1 April 2020
Project: 190038

**RE: JACKSON HARVEST FARMS, 1894 WITMER ROAD
PEER REVIEW RESPONSES**

The Township of Wilmot retained AECOM to perform a peer review and the results of the peer review were provided 4 February 2020. This letter provides responses to the comments made in the peer review.

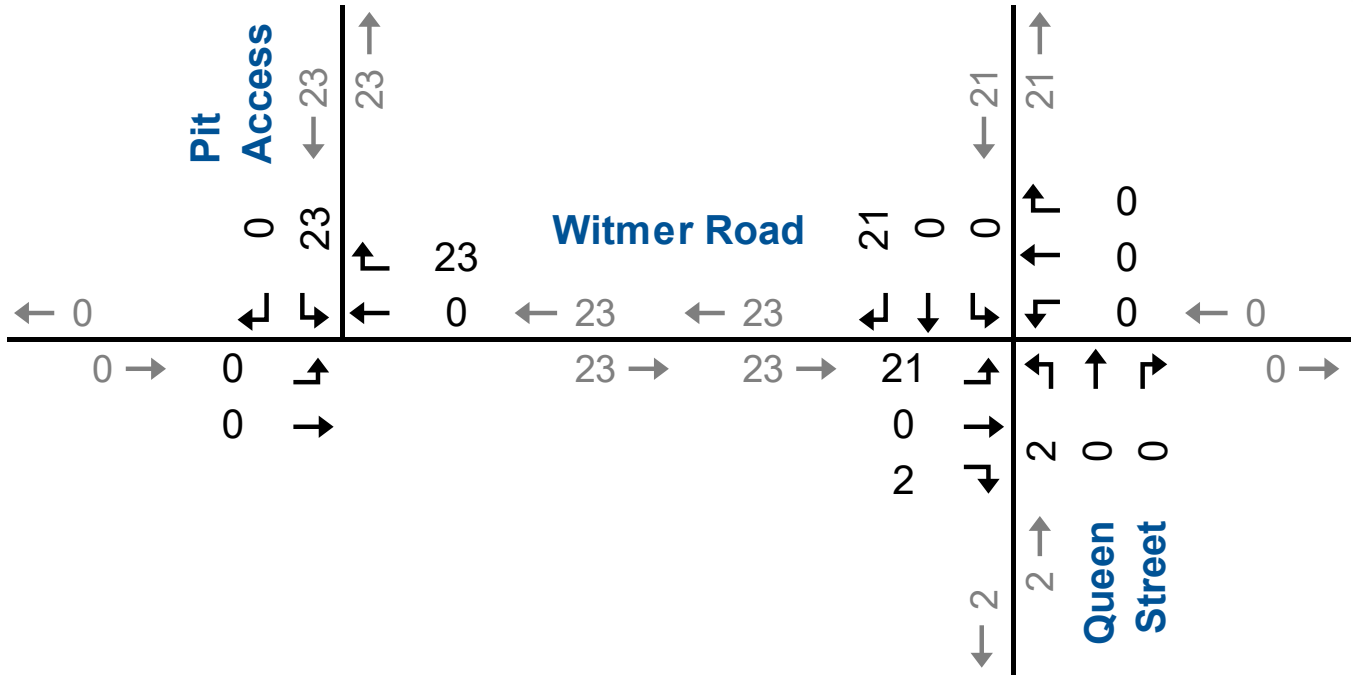
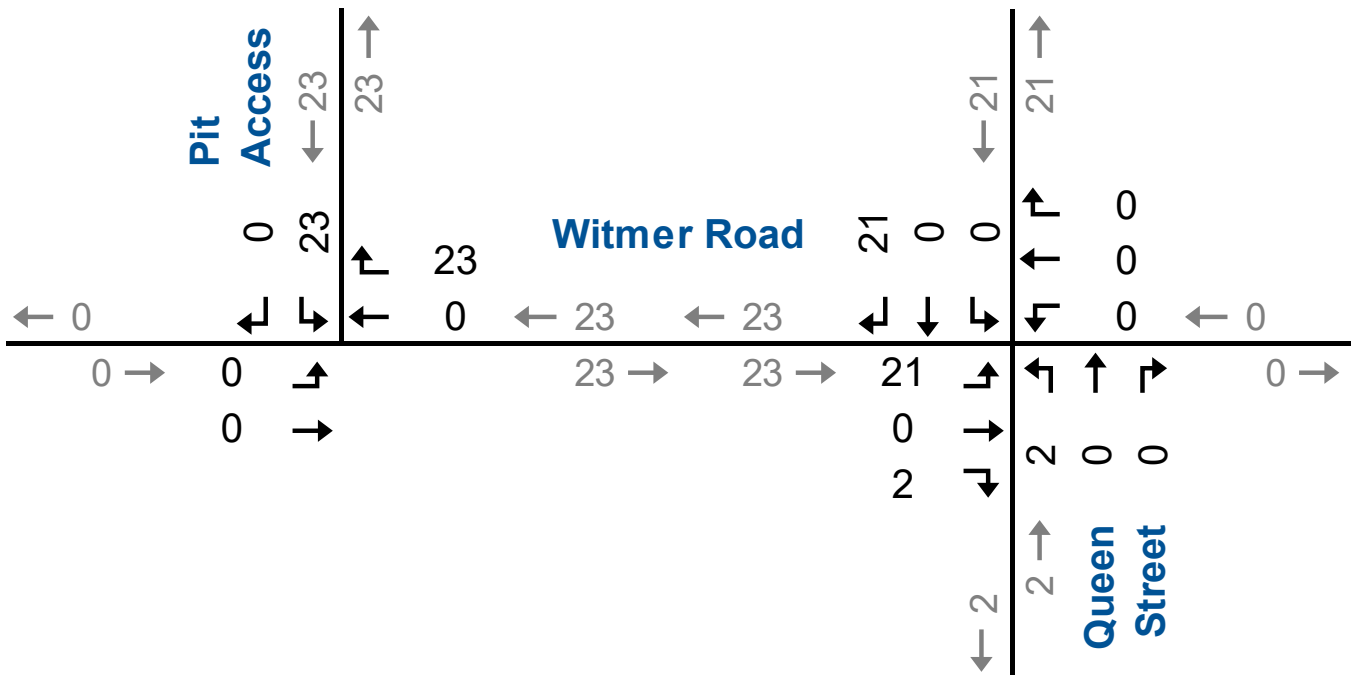
"The TIS Report does not account for receiving operations of the development site, including the deliveries of recycled asphalt and concrete and the resulting truck traffic volumes. These additional volumes should be included in the traffic analysis."

Information on the recycling operations were not available at the time of writing the TIS. A revised analysis including the expected trucks for the recycling operation was completed.

Recycled material operations will produce 30,000 tonnes per year in addition to the aggregates noted in the analysis contained within the TIS. **Table 1** summarizes the trip generation for the recycled materials.

Figure 1 (attached) illustrates the site generated traffic volumes for the AM and PM peak hours.

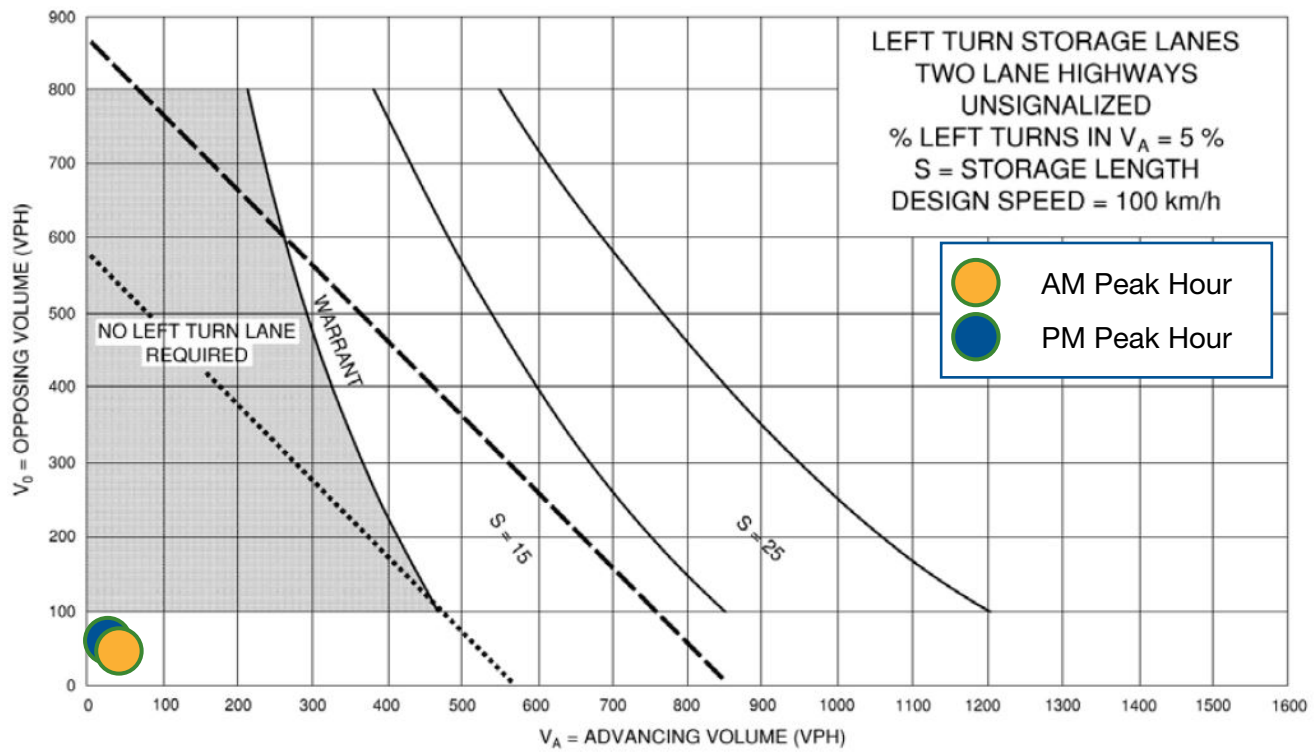
“Section 5.1 of the TIS Report concludes that since traffic volumes are forecast to be less than 100 vehicles/hour for both approaches in the AM and PM peaks, there is no requirement for auxiliary lanes.

The Consultant is advised to revisit this conclusion based on outcomes of all previous referenced comments in this peer review and cite all applicable standards or guidelines in support of their conclusion(s).”

The need for designated left turning lanes at intersections within the study area are assessed using MTO procedures detailed in the Geometric Design Manual³. The southbound left-turn lane for the intersection of Pit Access and Witmer Road is identified as unwarranted under 2023 total traffic conditions.

Figure 3 (attached) illustrates the left-turn lane warrant nomograph for the intersection of Pit Access and Witmer Road.
